WALTER J PATON ELEMENTARY SCHOOL
Grafton Street
Shrewsbury, MA 01545

PROJECT: TOWN OF SHREWSBURY ACCESSIBILITY PROJECT
 PATON ELEMENTARY SCHOOL
 DRAWING: FLOOR PLANS
 SCALE: 1" = 20'-0"
 DATE: FEBRUARY 2002

FIRST FLOOR PLAN

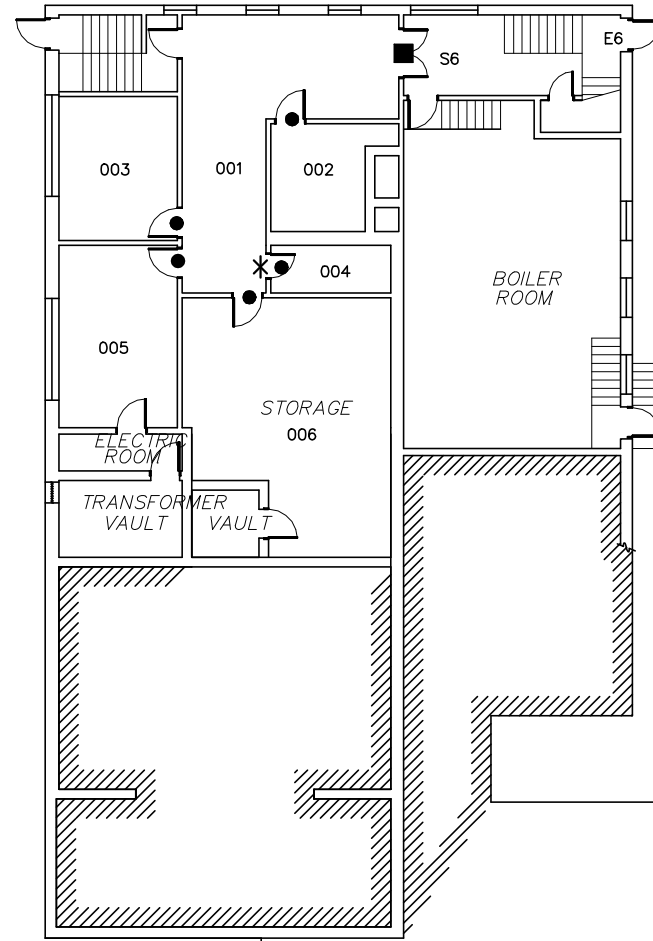
<i>Item</i>	<i>Action Required</i>	<i>Est. Cost</i>	<i>Priority</i>	<i>Feasibility</i>
Corridors 110, 111, 208 and 201: electrical outlets too low	Raise outlets	4,000	3	3

<i>Item</i>	<i>Action Required</i>	<i>Est. Cost</i>	<i>Priority</i>	<i>Feasibility</i>
2 single doors do not have a 32" clear opening	None, both lead to non-accessible spaces.	-	-	-
12 pairs of doors do not have a 32" clear opening.	Replace leaves with 36" and 28" wide leaves.	10,000	2	3
21 doors do not have 18" clearance on the pull side.	Although difficult to accomplish, all classroom doors should be reconfigured. (18) All others lead to non-accessible spaces	90,000	2	3
4 doors do not have the 12" clearance on the push side.	We recommend relocating door 116-132 only. All others lead to non-accessible spaces.	1,500	3	3
38 doors have knob hardware.	Replace with lever hardware.	8,000	2	2
10 doors have closers that close too fast or too difficult to operate.	Replace or adjust closers.	5,000	2	2

<i>Item</i>	<i>Action Required</i>	<i>Est. Cost</i>	<i>Priority</i>	<i>Feasibility</i>
Pull stations in rooms 110, 121, 201 and 208 are mounted too high	Lower pull stations to 48" a.f.f (6)	1,500	4	3
No strobes in rooms 109, 110, 111, 121, 208, T3, T4, T5, T6, and T7.	Add strobes (10)	3,500	4	3
	Add new power booster for signal circuits	1,200	4	3

BASEMENT FLOOR PLAN

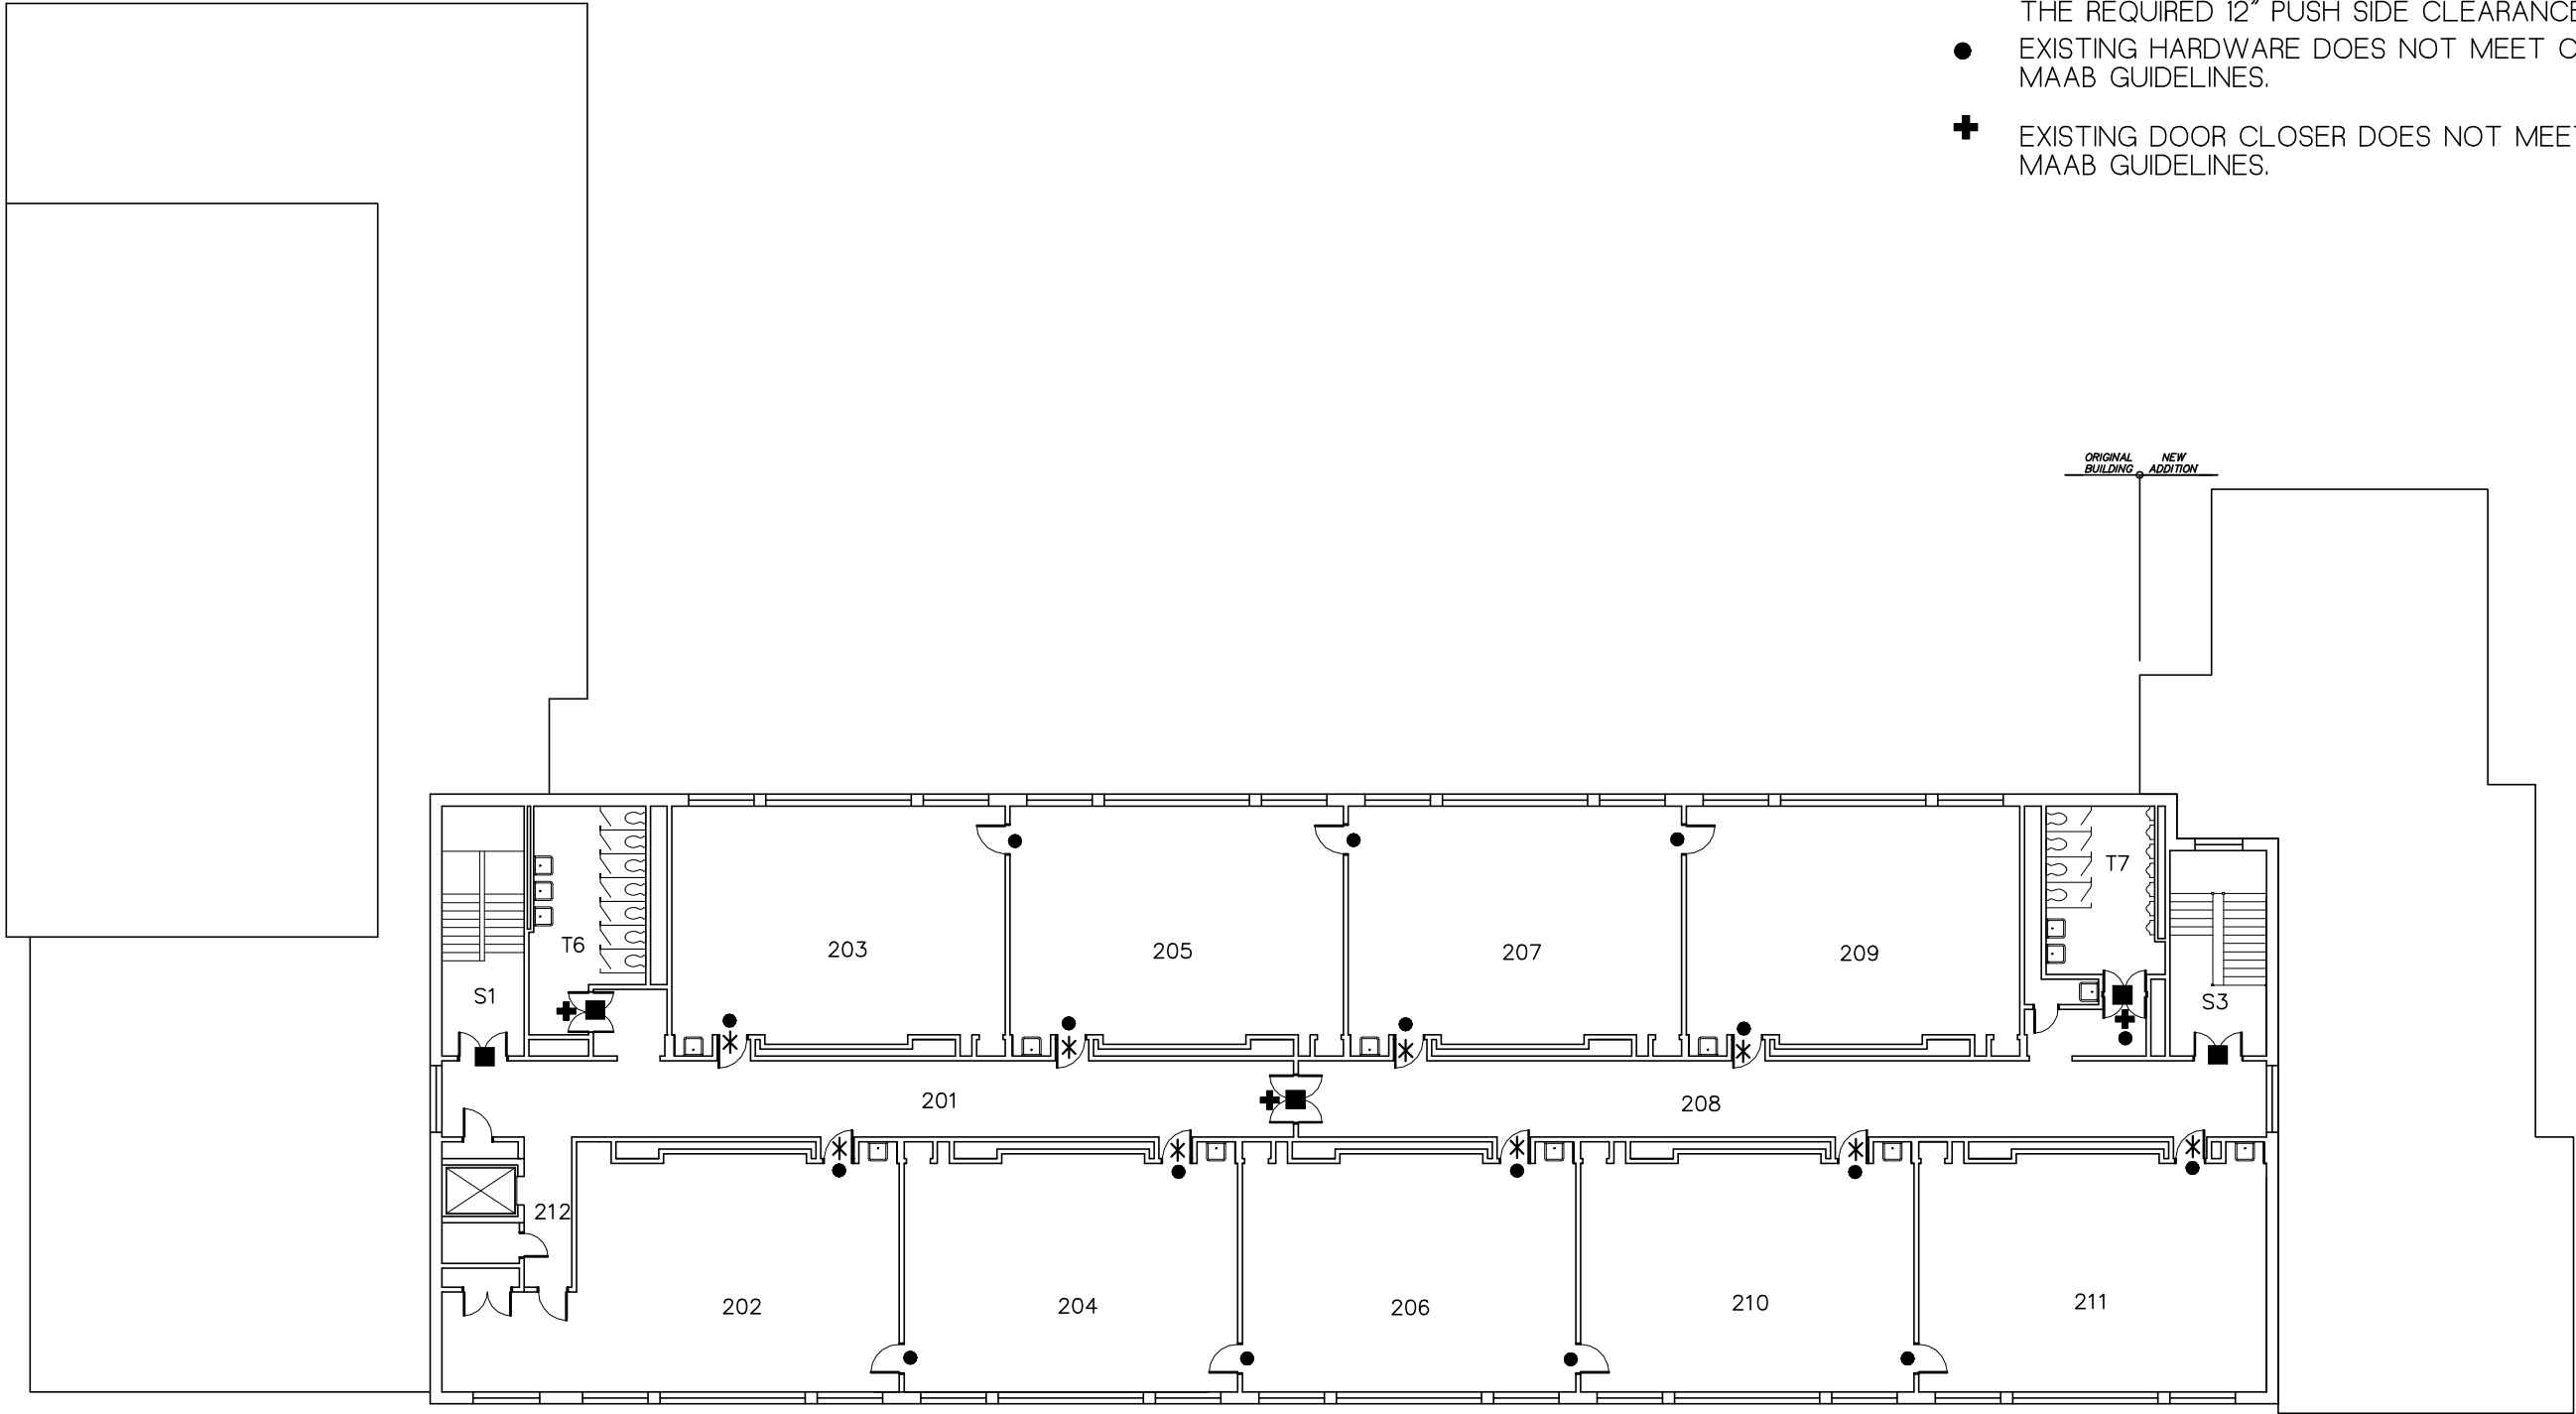
<i>Item</i>	<i>Action Required</i>	<i>Est. Cost</i>	<i>Priority</i>	<i>Feasibility</i>
Toilets T1, T2 and T4 No 5' diameter turning area, Insufficient clearances at door, toilets and lavatories.	We recommend complete reconstruction of Toilet T4 into a fully accessible men's and women's toilet rooms.	50,000	3	3
Toilets T3, T5, T6 and T7 Accessible stall is 1" too short.	None, lengthening stall will decrease access to the stall.	-	-	-
Latch is at the incorrect height, some door pulls are missing, no coat hooks.	Replace with a new door, latch, pulls and coat hooks	1,600	3	3
No accessible door sign	Provide signs	600	3	1
